GE Nuclear Energy

MFN 050-96
Docket No. 52-001

ABWR Design Change Assessment Review of FOAKE Design Changes

PROPOSED CHANGES

Figure 2.11.3a Reactor Building Cooling Water System (RCW-A)

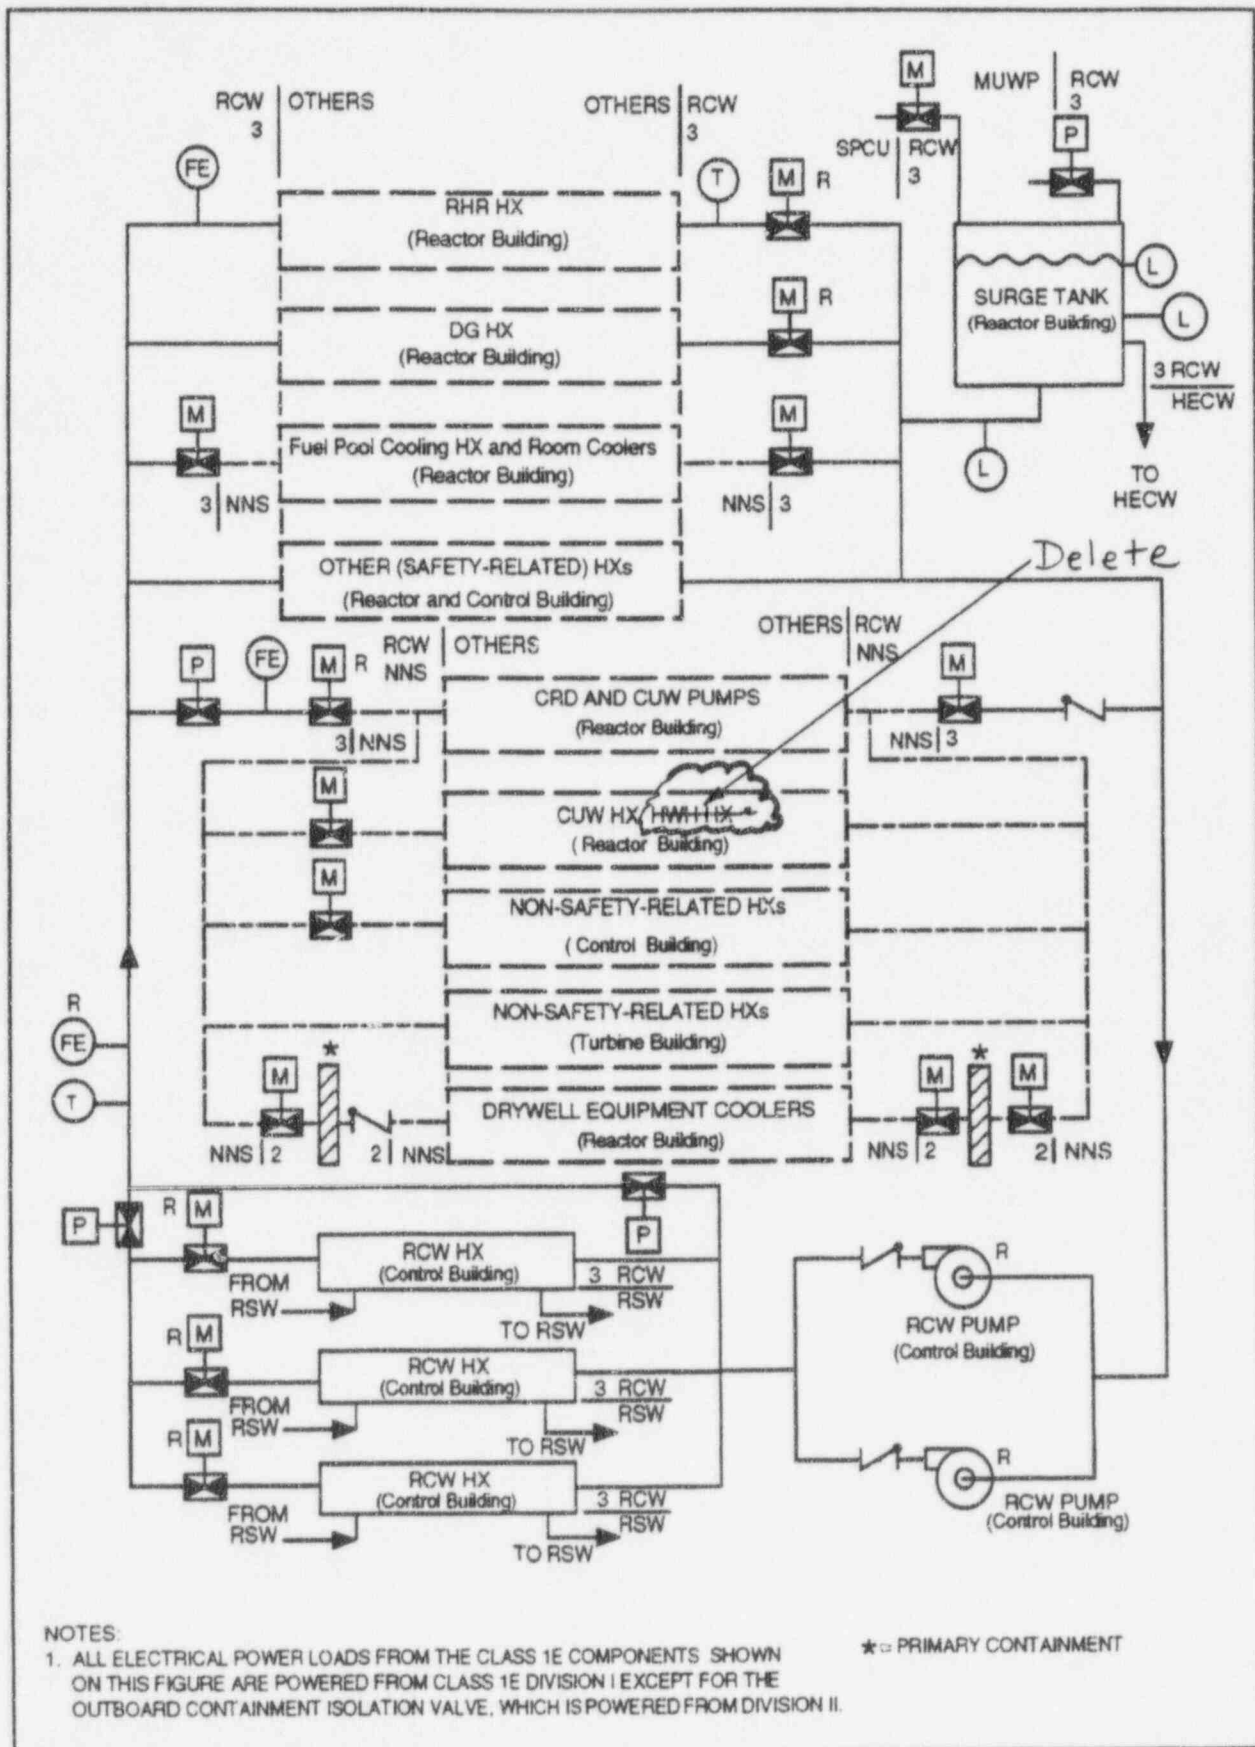
**Eliminate Hot Water Heating
for RB and RWB HVAC**

FIGURE 9.2-1 REACTOR BUILDING COOLING WATER SYSTEM P&ID (Sheet 2 of 9)

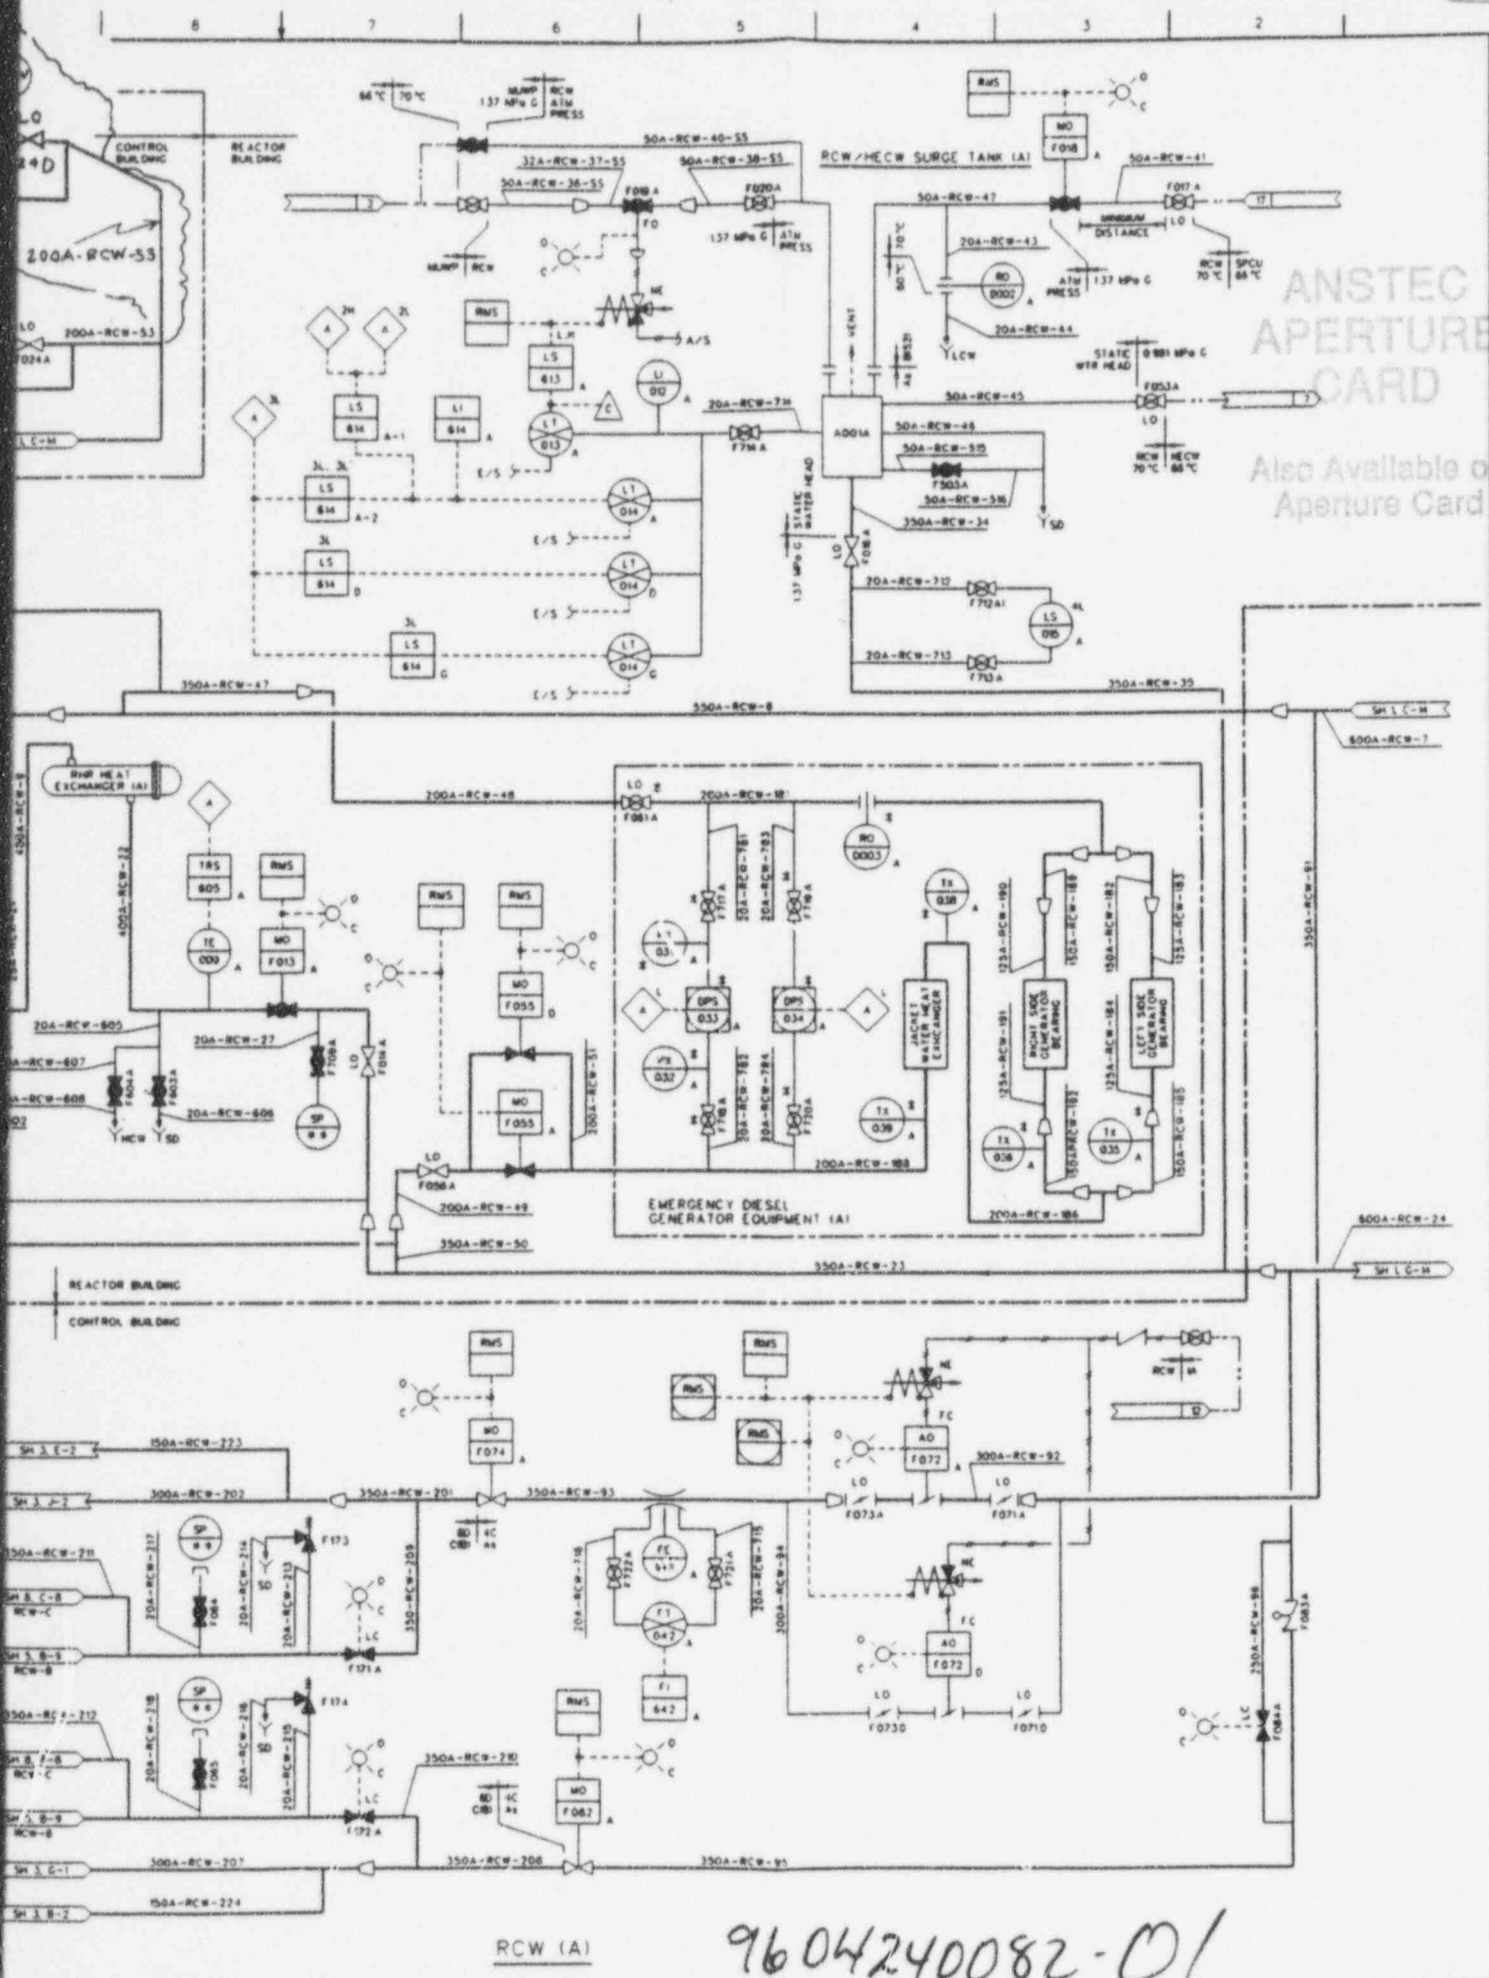
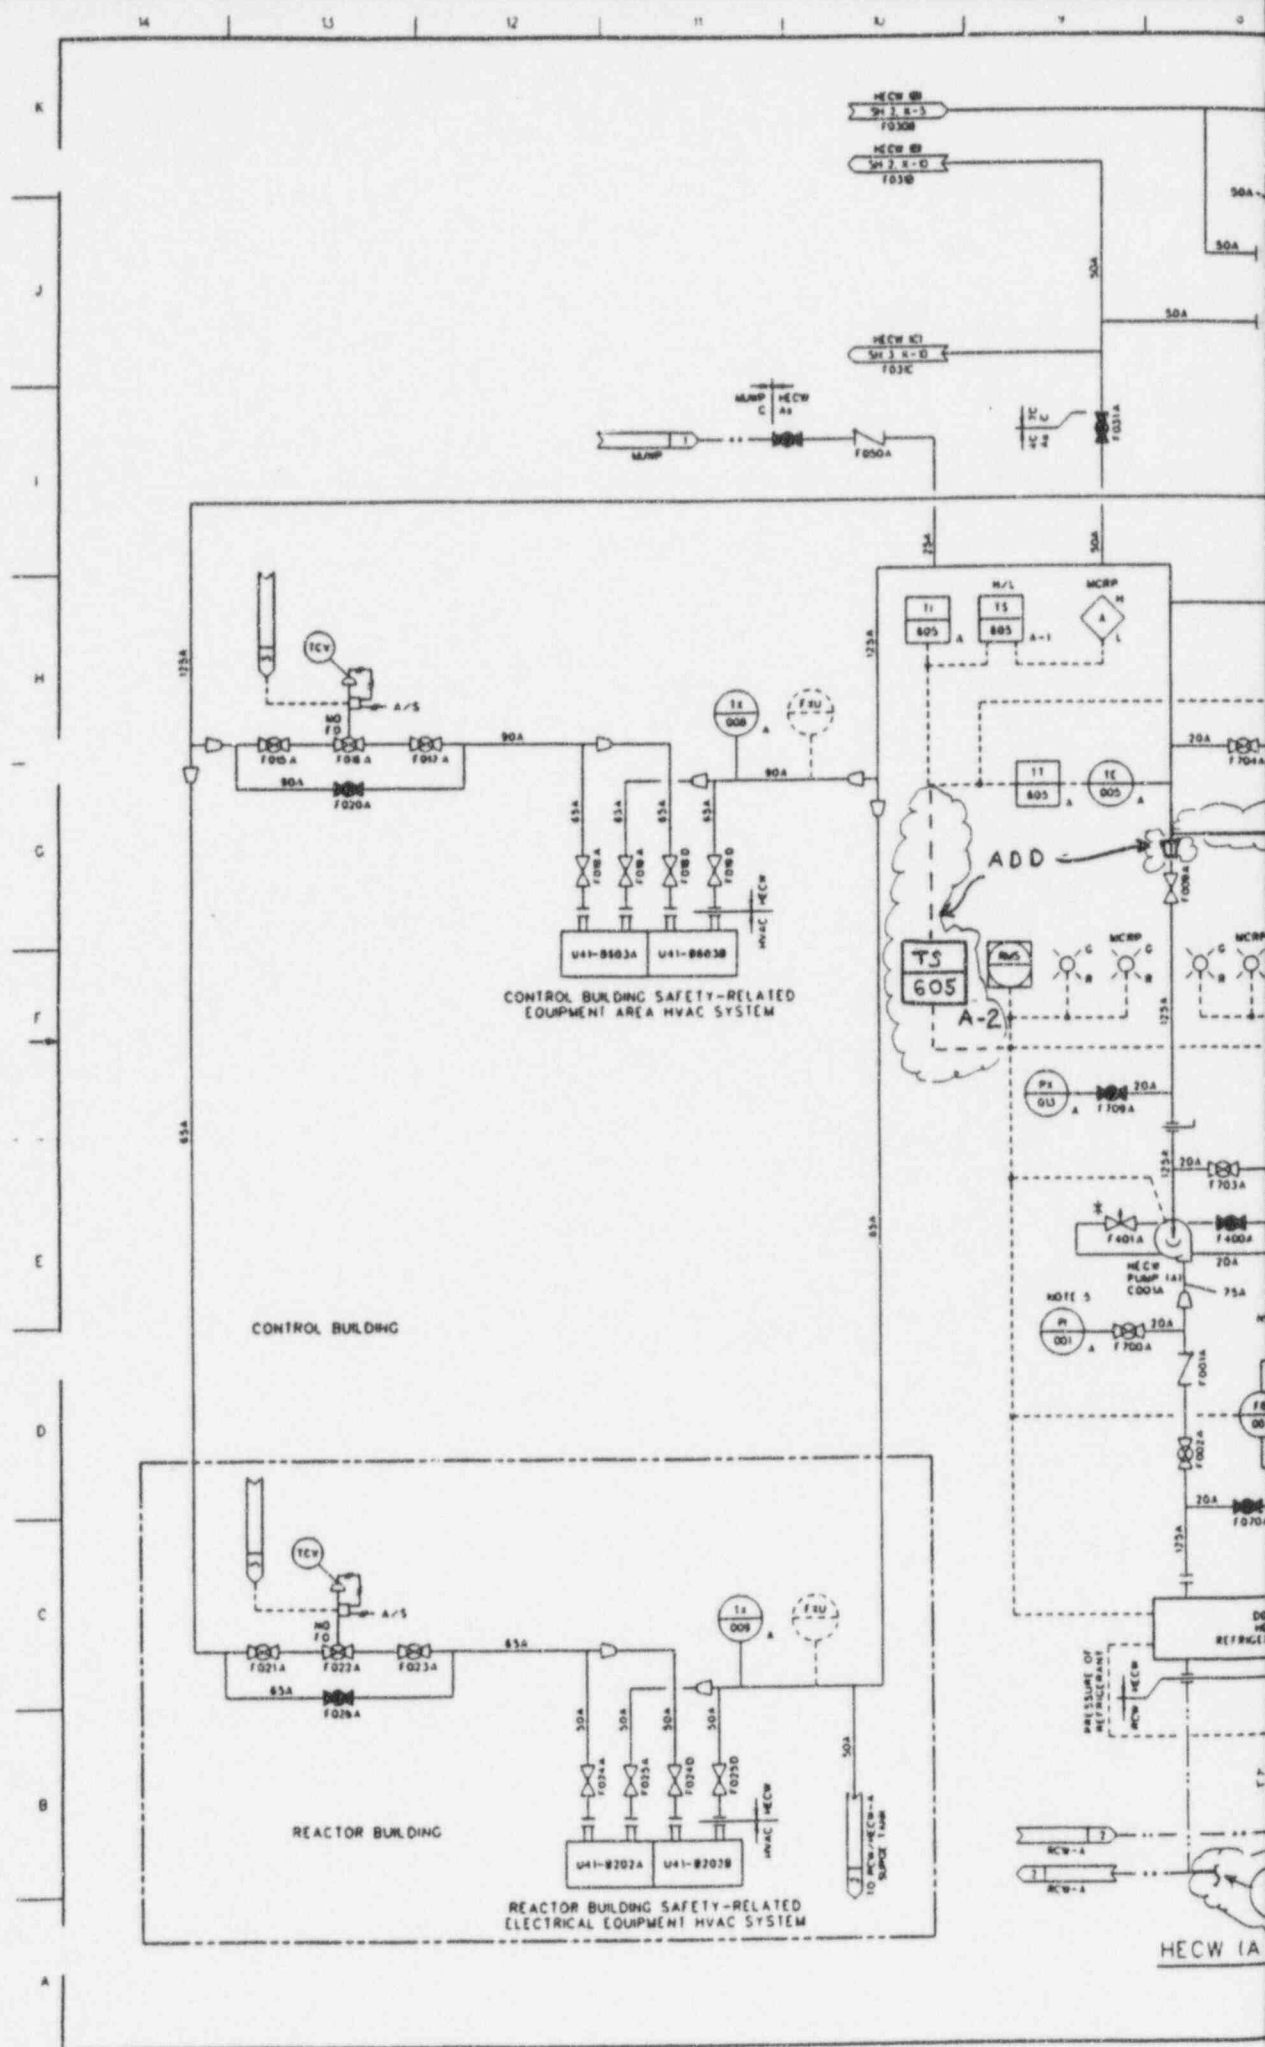
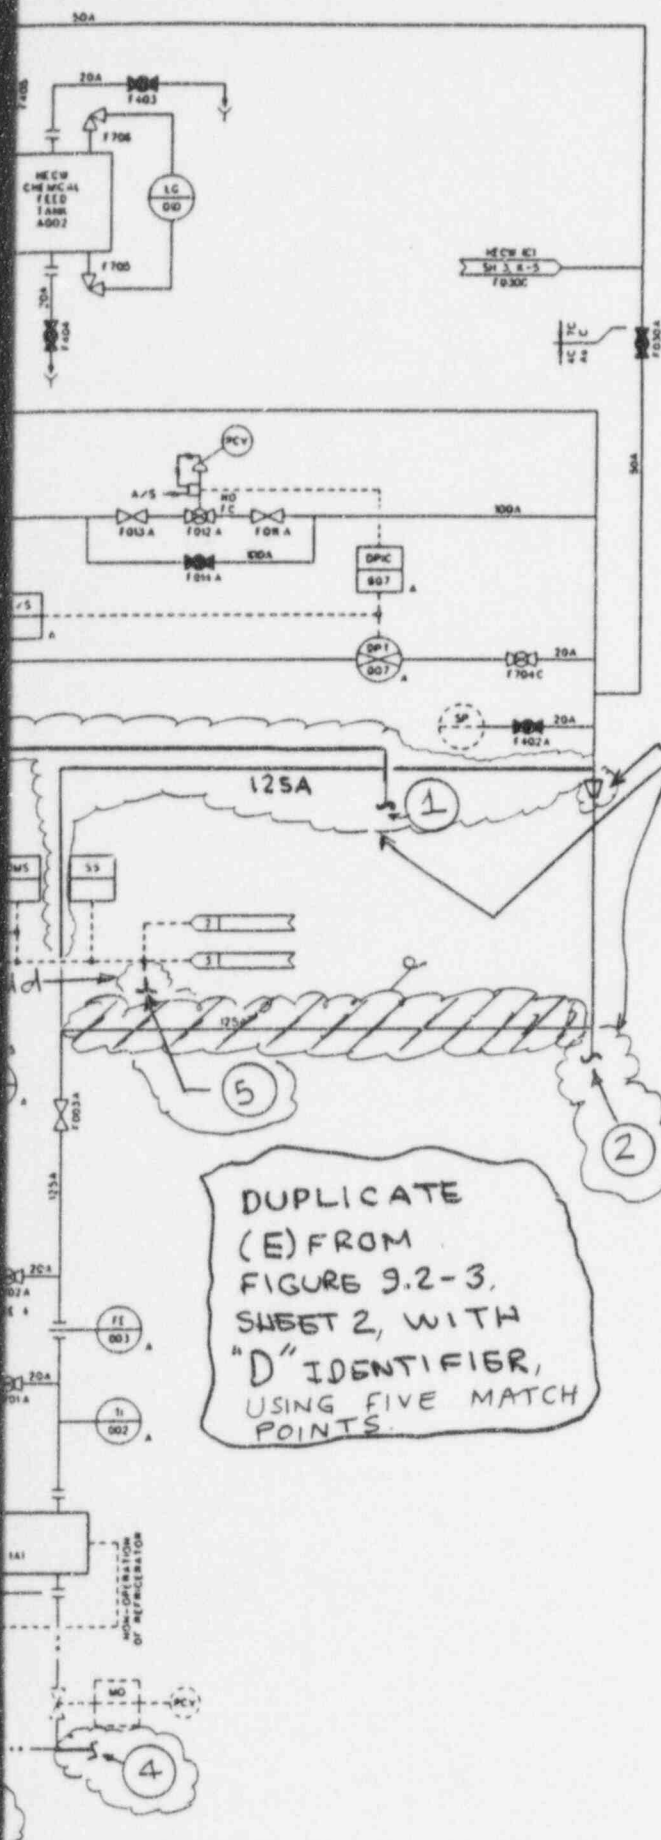
ADDITION OF DIVISION "D"

ADD

FIGURE 9.2-3 HVAC EMERGENCY COOLING WATER SYSTEM P&ID (Sheet 1 of 3)

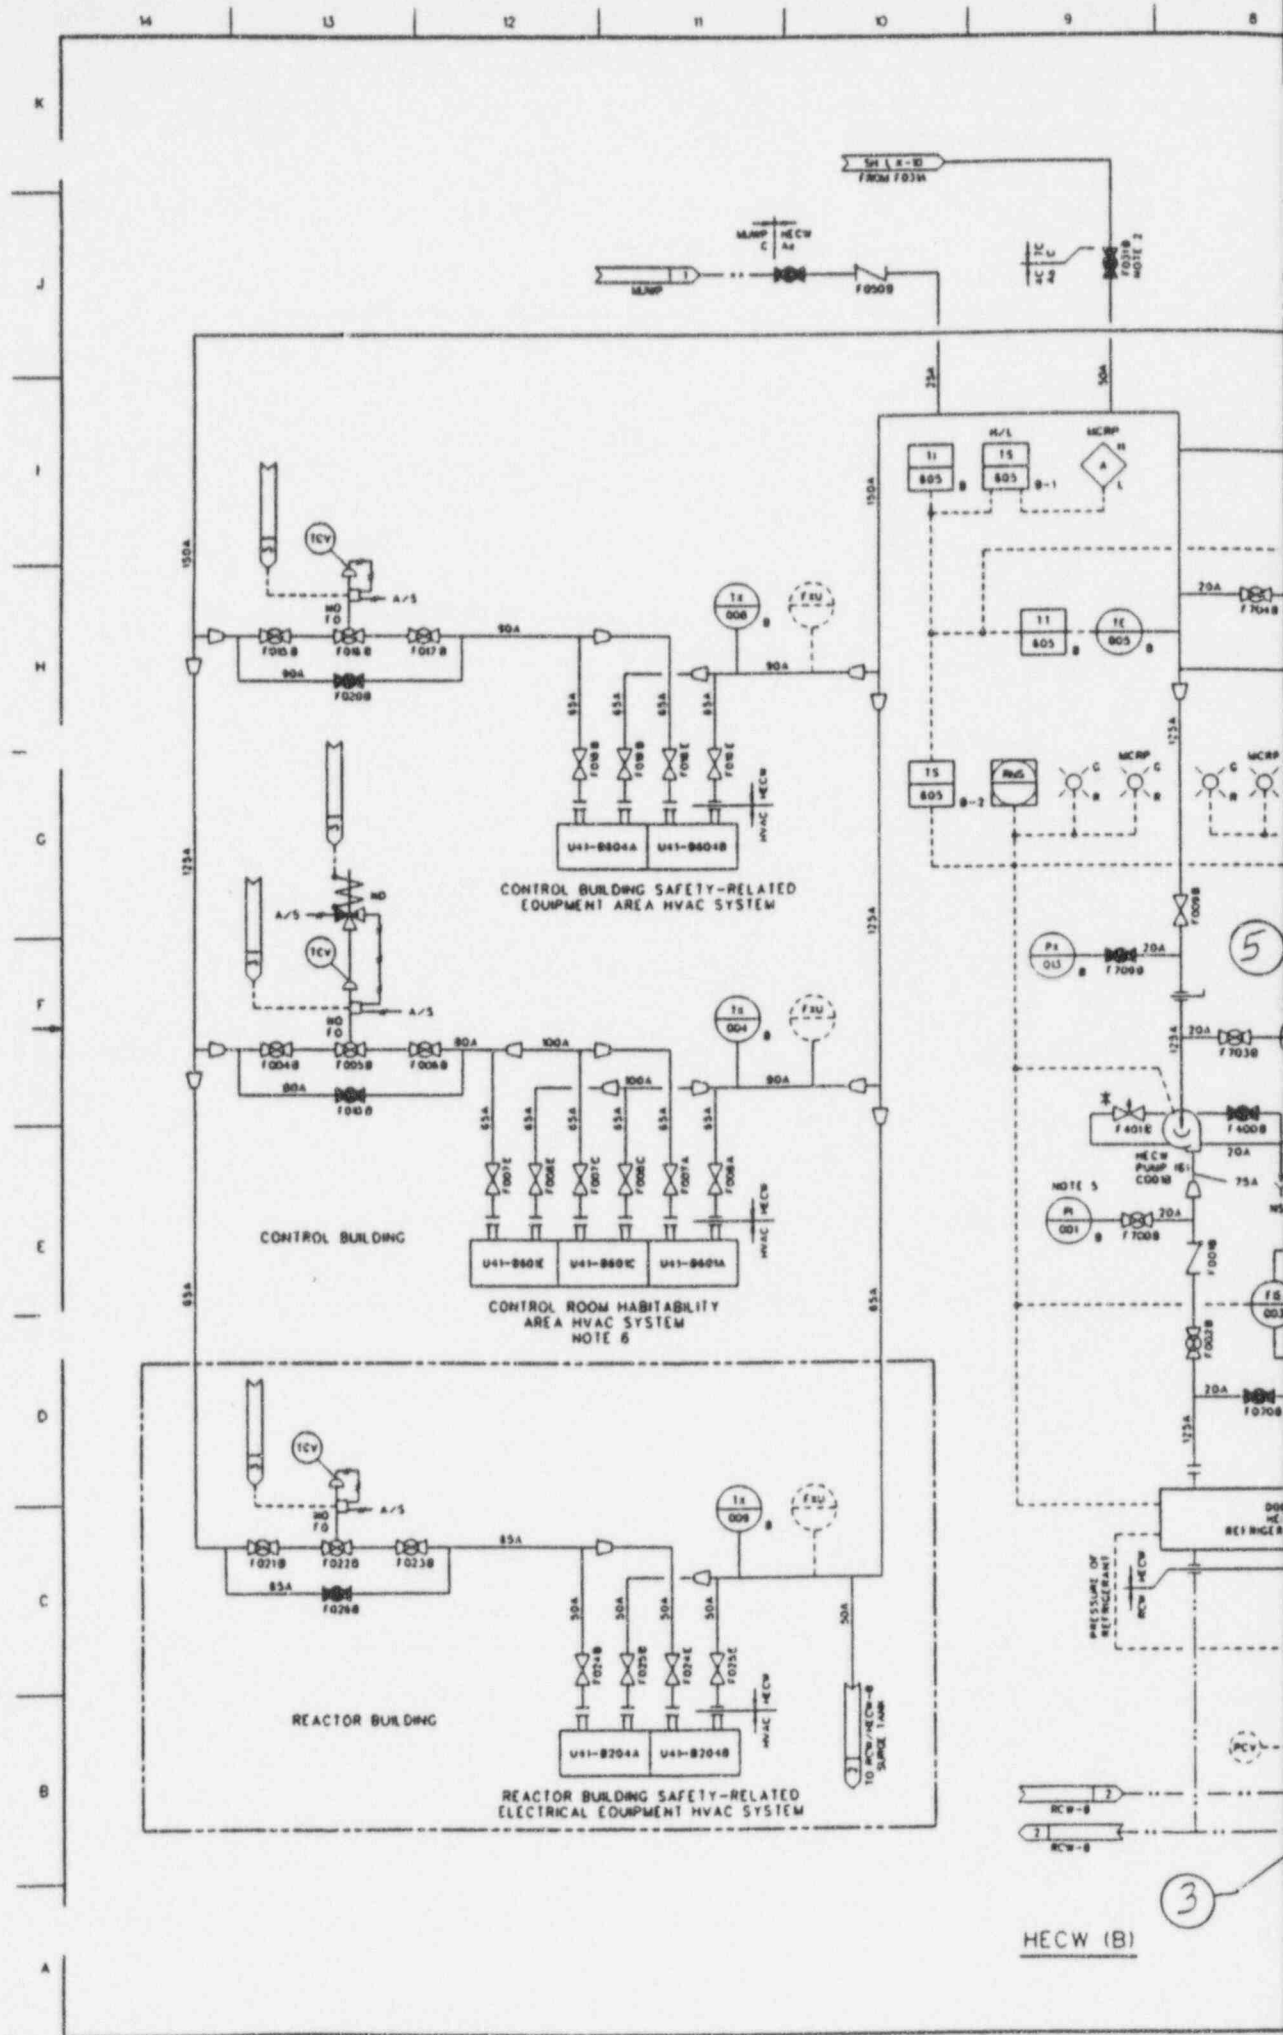
DUPLICATE (E) FROM FIGURE 9.2-3, SHEET 2, WITH "D" IDENTIFIER, USING FIVE MATCH POINTS.
